SECTION II

MODIFICATIONS TO THE LNG EXPORT PROJECT DESIGN

Figure 2.4 Wet and Dry Gas Flares

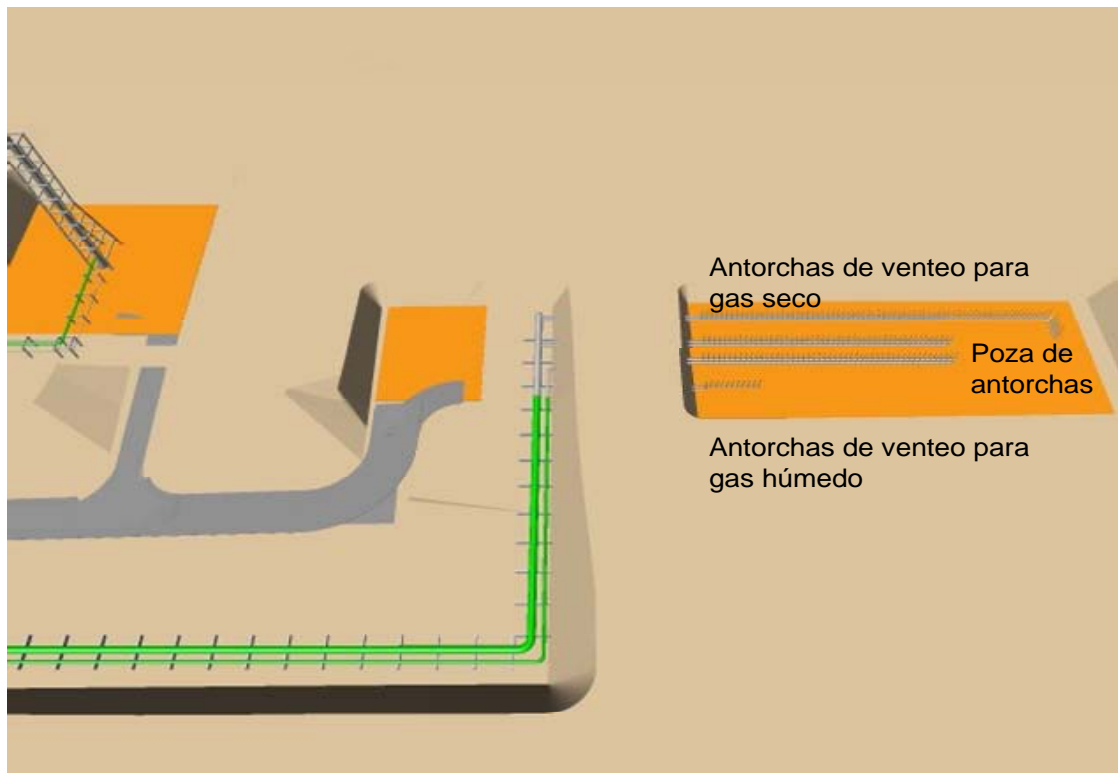
The original wet and dry gas flare system designed for the plant consisted of a two-stage vertical ground flare. The new design now has a horizontal system parallel to the ground surface and contained in a flare pit, producing less emission and lower thermal radiation. The previous design consisted of two wet and dry gas flares installed on a common tower (see Chapter II, Section 2.3.8 of the EIA). The current design proposes the installation of a series of small flare tips in a pit to reduce the effect of thermal radiation (see **Figure 2.4**). At the same time, the combustion using small flare tips is more efficient than using a single large flare, generating less atmospheric emissions.

Figure 2.7 Diesel and Gasoline Storage

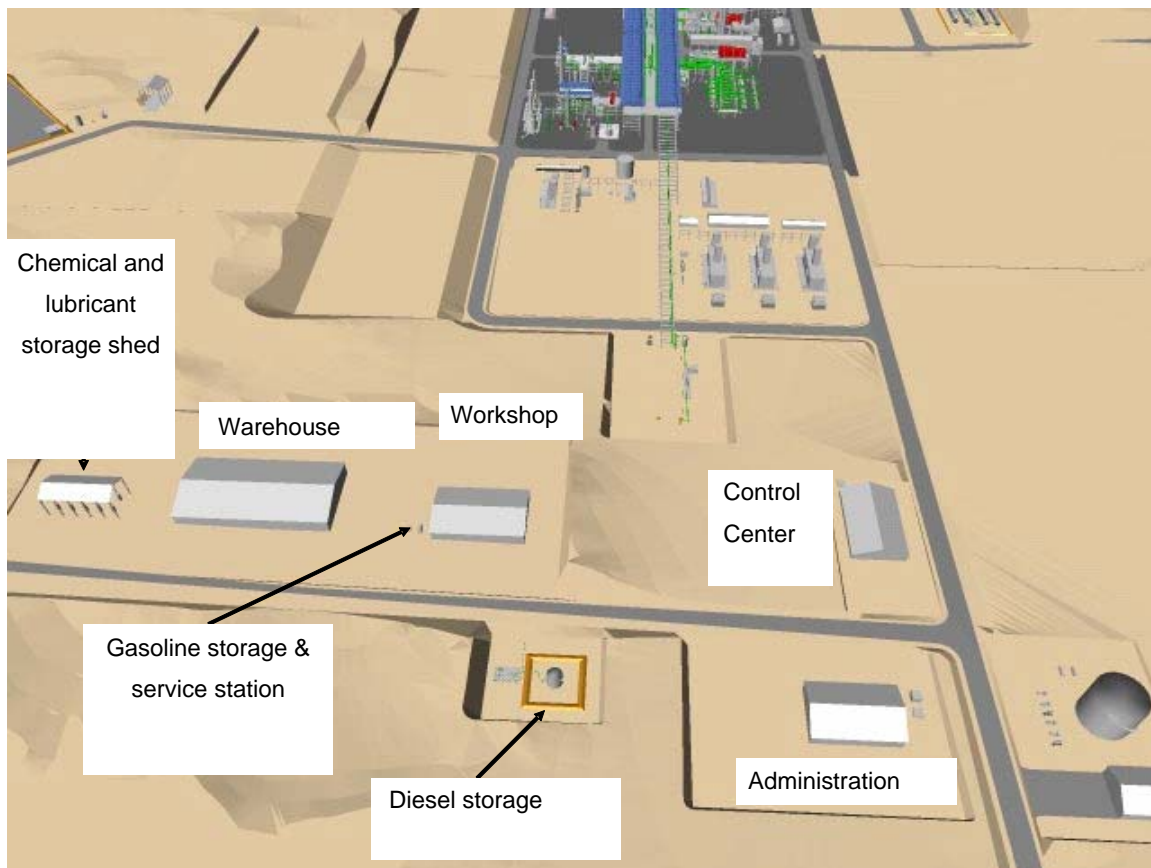
The diesel fueling area was moved from the plant area (see Section 2.3.4 Chapter II) to the administration building for safety reasons (see **Figure 2.7**). This new location will allow safer diesel fueling operations to tank trucks located outside the plant area. The size of the diesel storage tank has not been changed.

The on-site gasoline fueling system for light vehicles and trucks will have a horizontal storage tank with 8m³ or 2,100 US gallons capacity located above ground in a containment dike.

Figure 2.8 *Division of the Electric Substation*

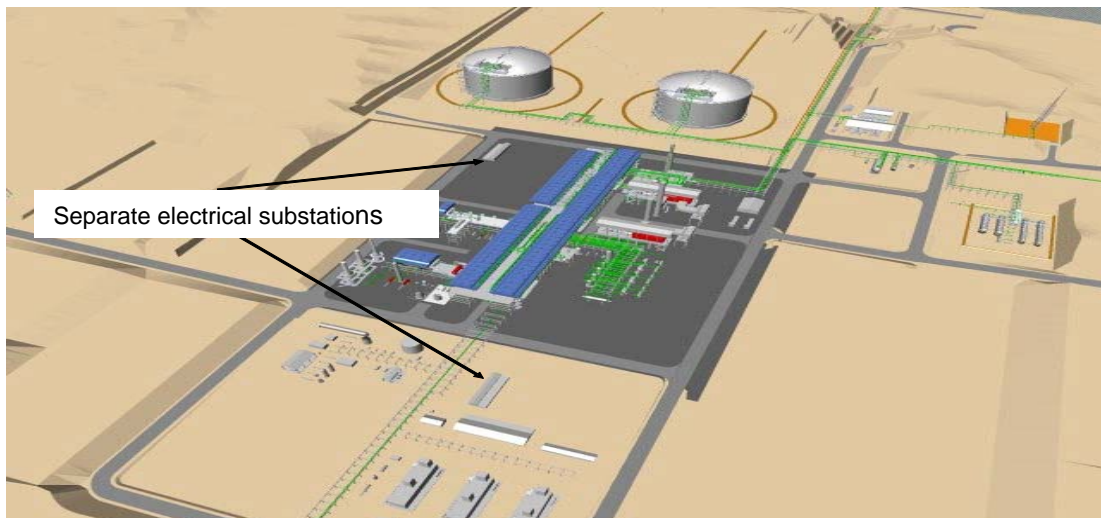
The Plant electrical substation was divided in two to reduce the electric wiring requirements and to use underground wiring for greater protection and safety (see **Figure 2.8**). Both substations are located far away from the equipment containing hydrocarbons.

Figure 2.9 Access Road to the Beach

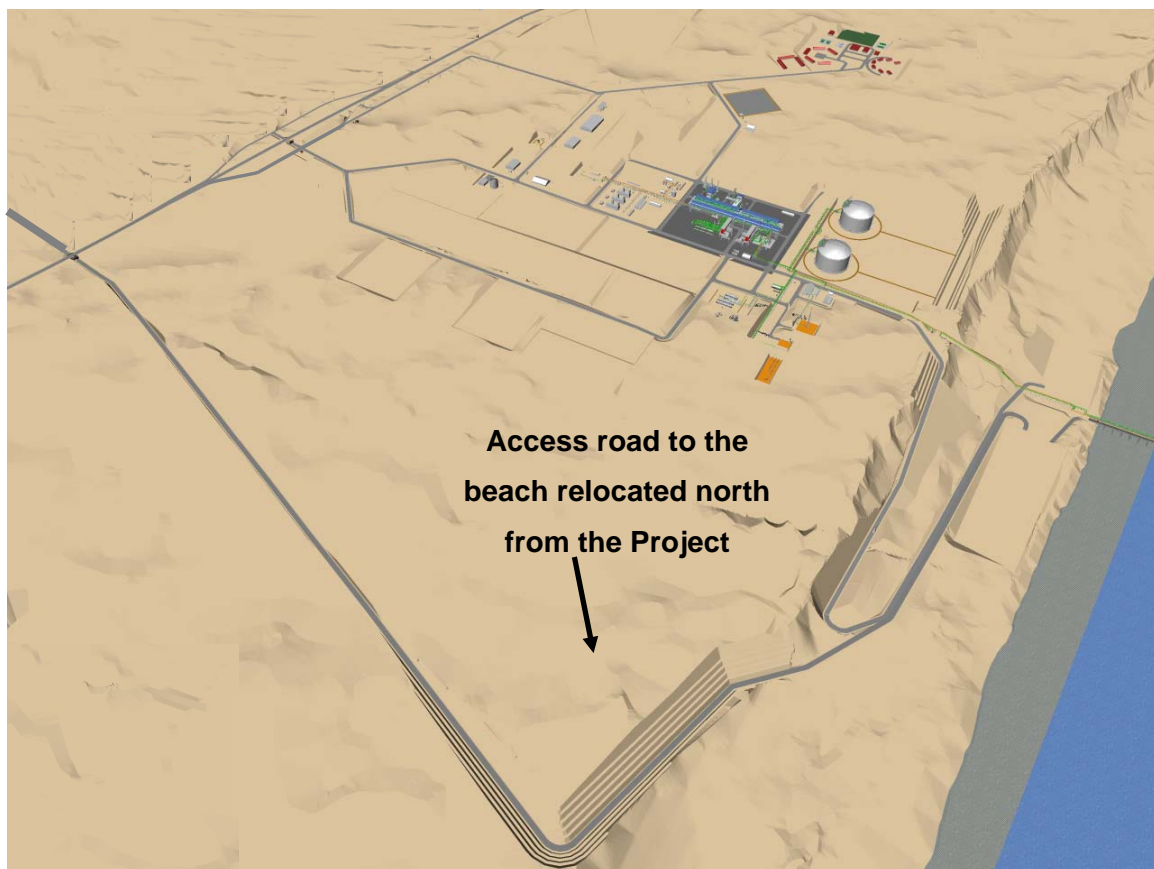
The access road to the beach was relocated along the northern property boundary and descends along the cliff to provide access to the work areas during plant construction and operations. (See **Figure 2.9**)

Figure 2. 11 ***Plant Plot Plan and Cross Section View of the Underpasses***

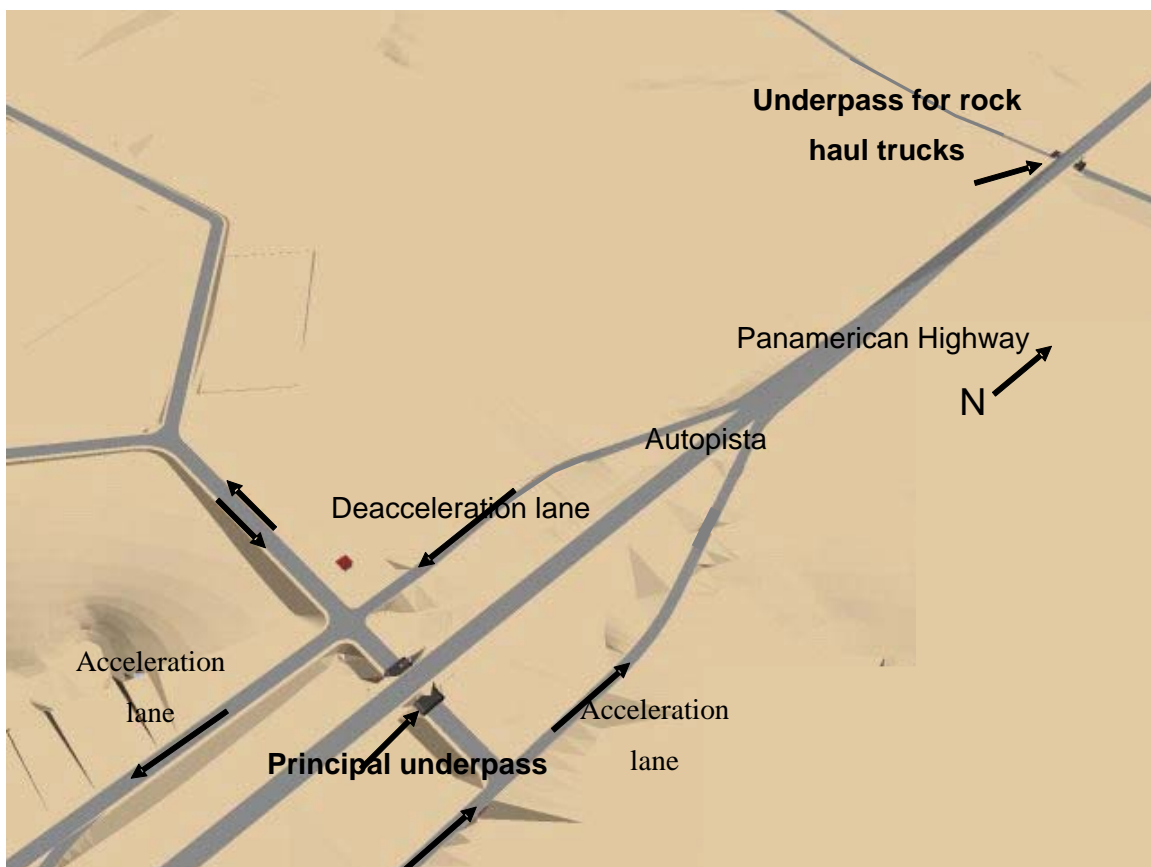
The proposed Plant access road includes the construction of two underpasses with parallel acceleration and deceleration lanes (see **Figures 2.10** and **2.11**). The underpasses will be used for: 1) allowing the entrance of vehicles from the Panamerican South Highway to the PLNG facilities, and 2) to facilitate the crossing of trucks hauling rock to be used during the plant's construction. The original access to the plant was through a direct detour road from the Panamerican highway. The use of underpasses will allow safe crossing without stopping traffic flow or reducing visibility.

Two gas pipelines, or their casings, will be installed across the Panamerican highway: one main gas pipeline and the other a temporary line to be used during construction of the plant. The approximate crossing point on the Panamerican highway is at coordinates 360243.70 east and 8536194.68 north, as shown in Figure 2.11.

Figure 2.12 Location of the Rock Load-out Jetty

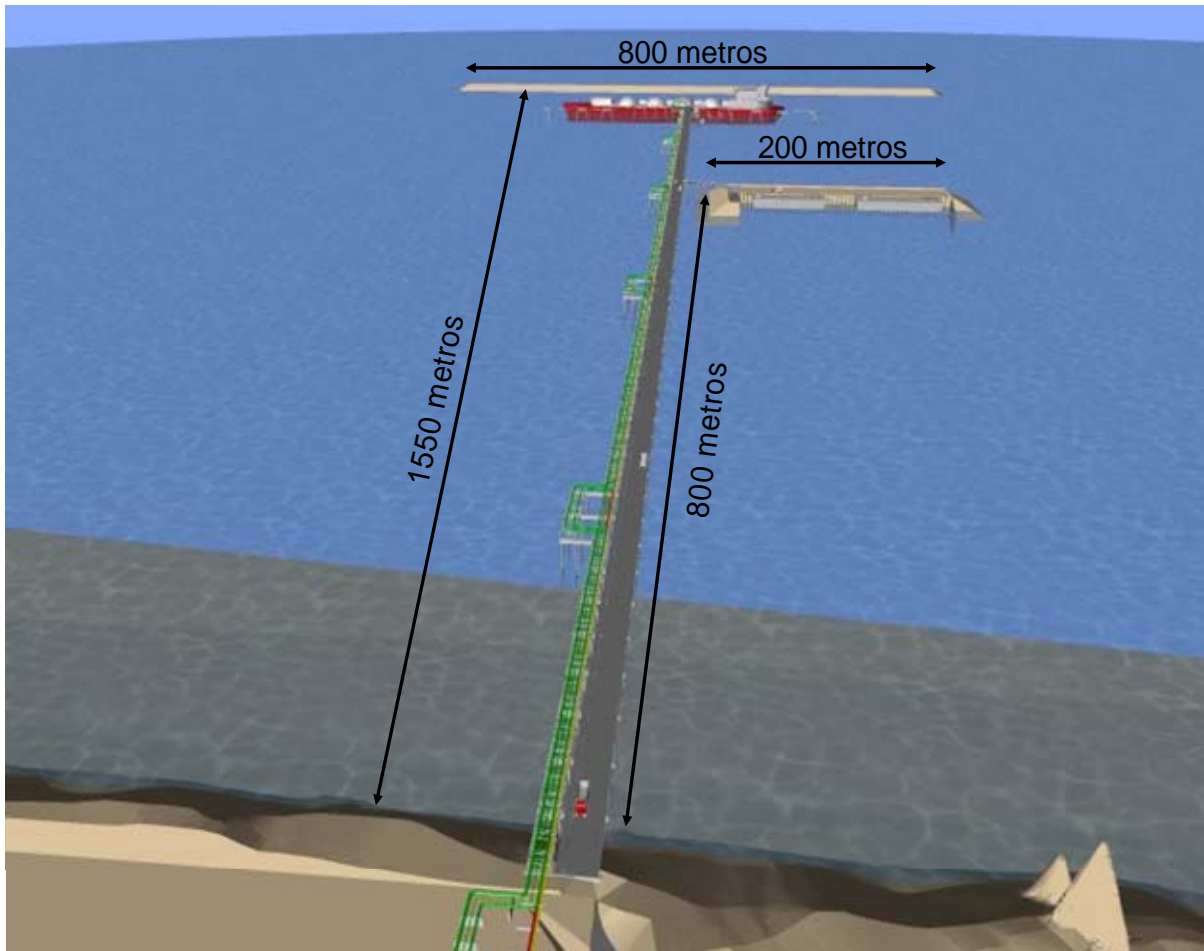
The rock load-out jetty will be 200 meters long and 8.00 meters above sea level (See **Figure 2.12**), and will be placed along the 10m depth contour of the seafloor with a similar structure to that of the breakwater.
